Connah's Quay Low Carbon Power

Applicant's Response to Deadline 6 Submissions

Document Reference: EN010166/APP/9.40

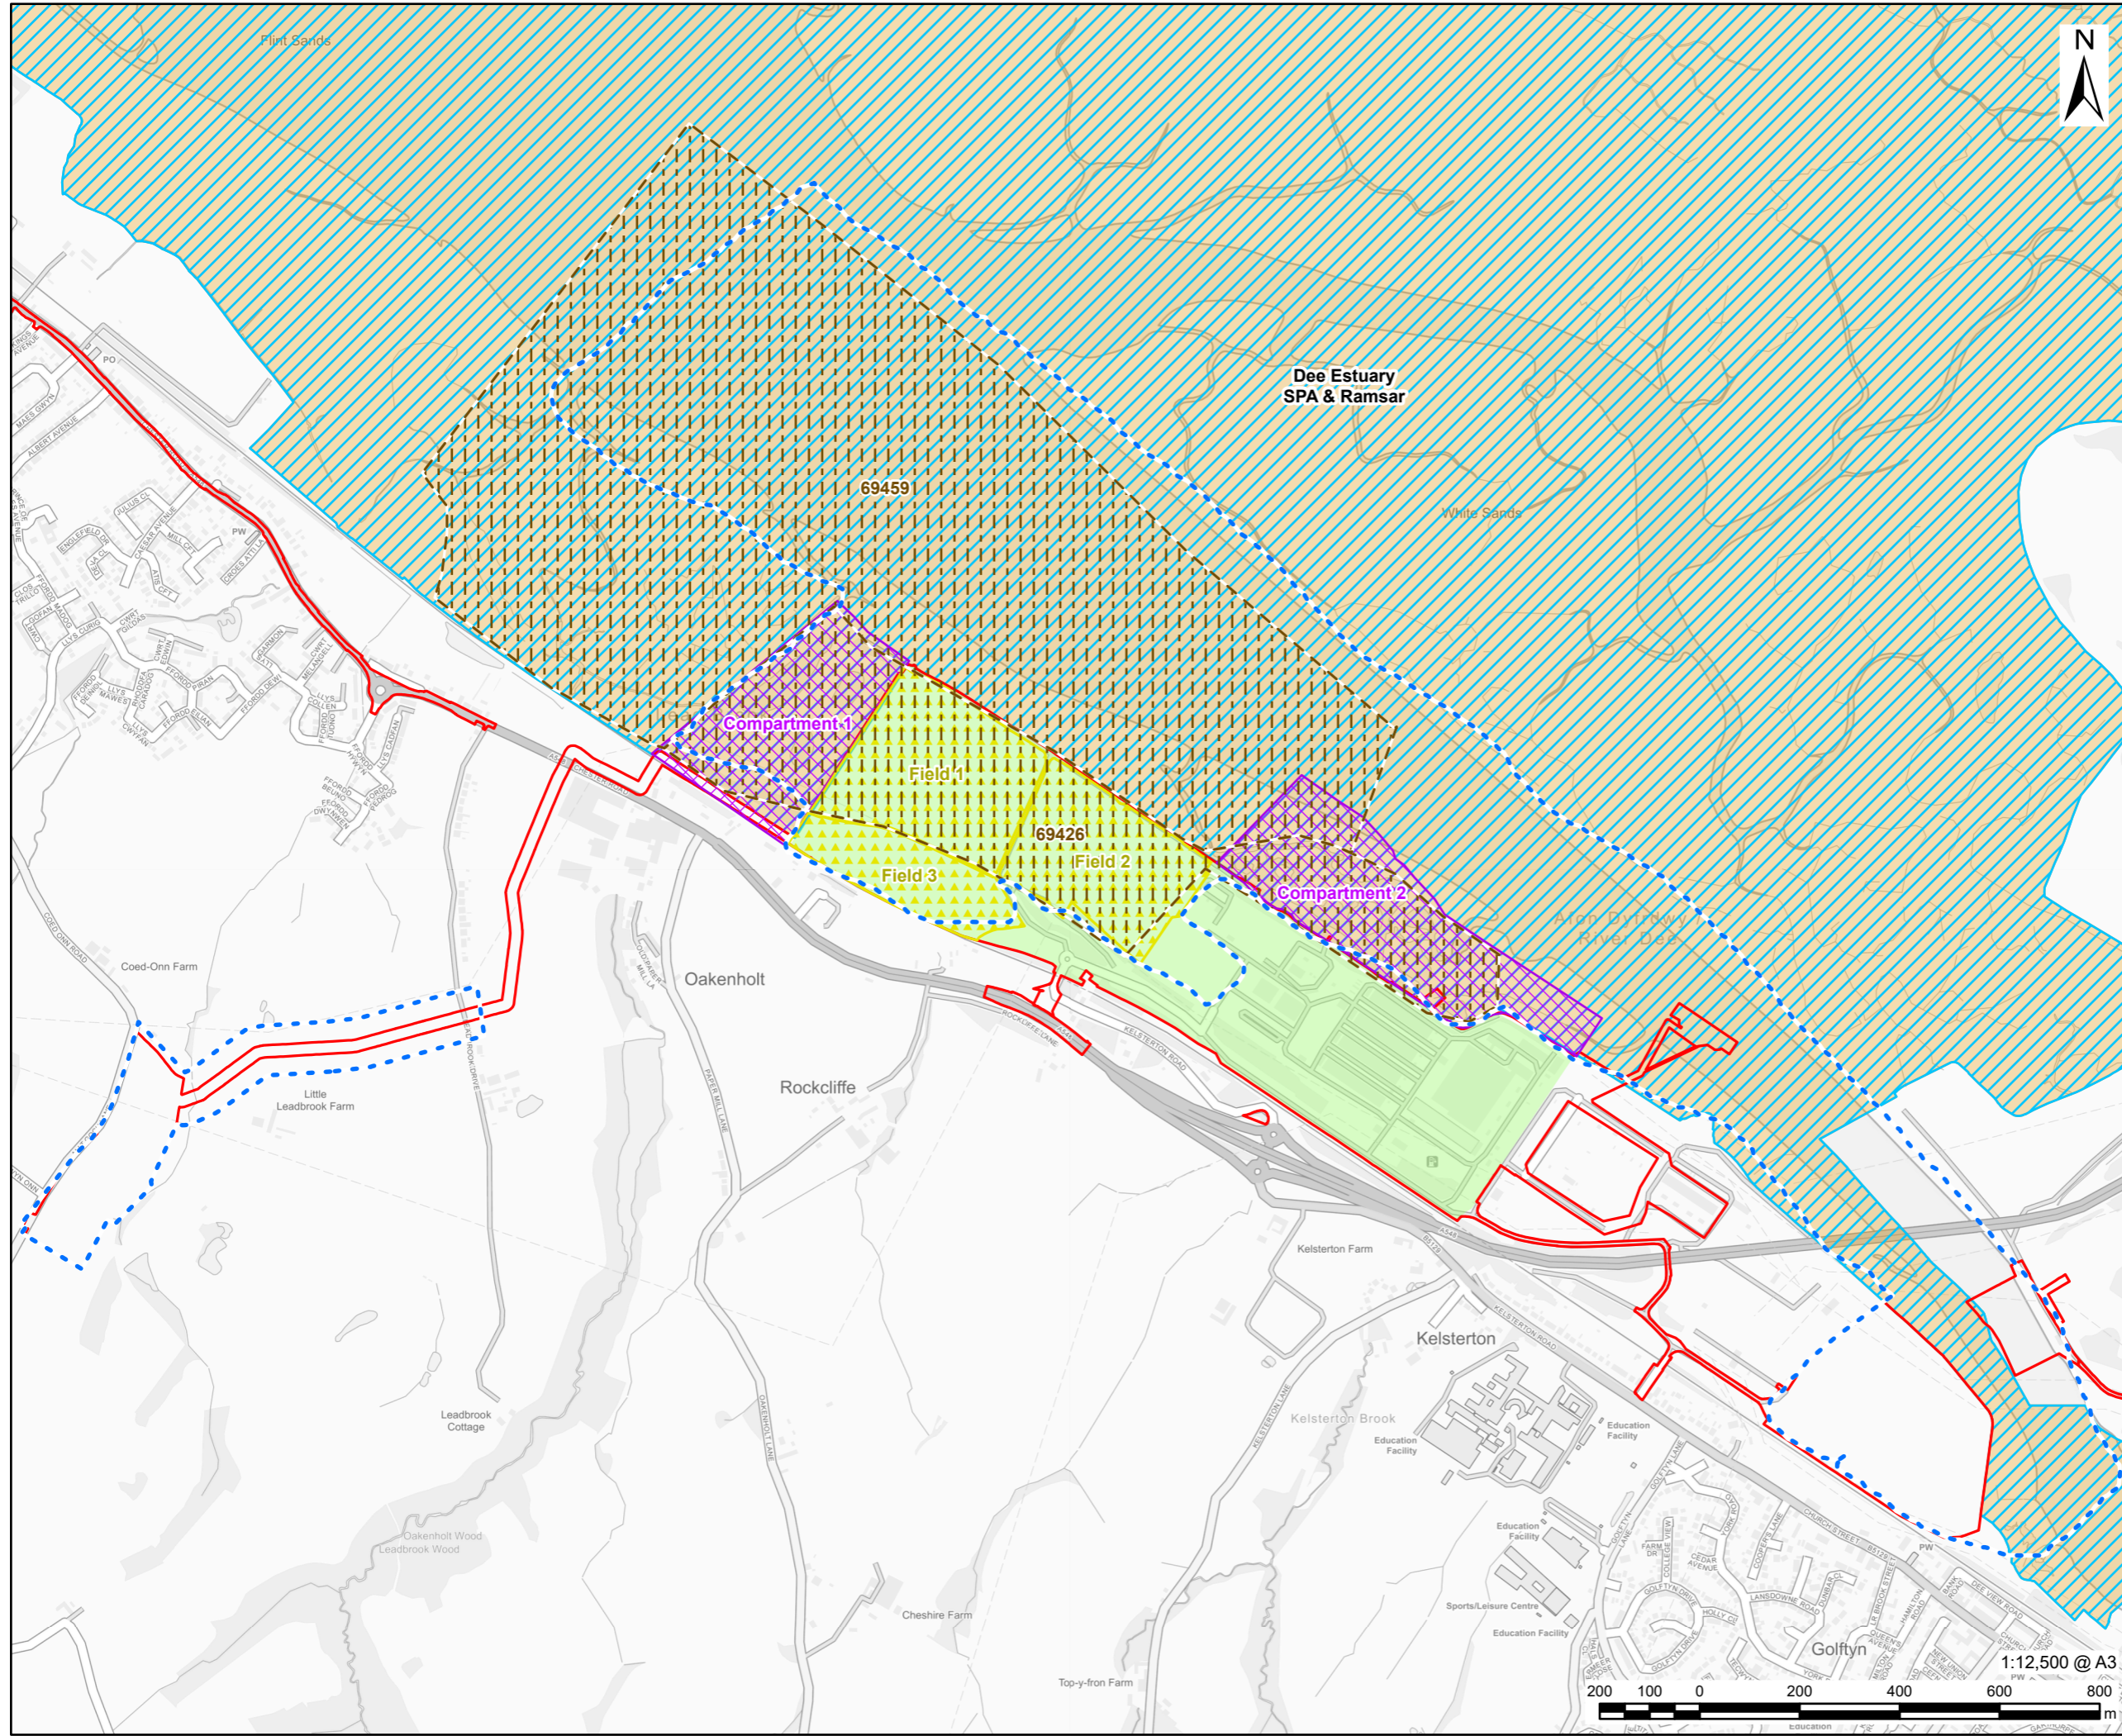
2.3	Traffic and Transport	<p>Question Reference: Q8.1</p> <p>Examining Authority Question: Increase in traffic movements ([APP-048] Table 10-28)</p>	<p>The Applicant provided a response to this point within the Applicant's Response to ExQ2 [REP6-087], which directly addresses the matters raised by FCC. For ease of reference, the relevant parts of the Applicant's response are copied below:</p>

Source Document	Reference	Topic	Source Document Text	Applicant's Response
			<ul style="list-style-type: none"> Strengthening of workforce travel measures within the Construction Worker Travel Plan (CWTP) [APP-248] to further reduce single-occupancy vehicle trips. <p>FCC is satisfied that this escalation-based approach, secured through Requirement 5 and subject to approval by FCC, provides sufficient flexibility to respond proportionately to actual on-site conditions, without necessitating further assessment at this stage.</p>
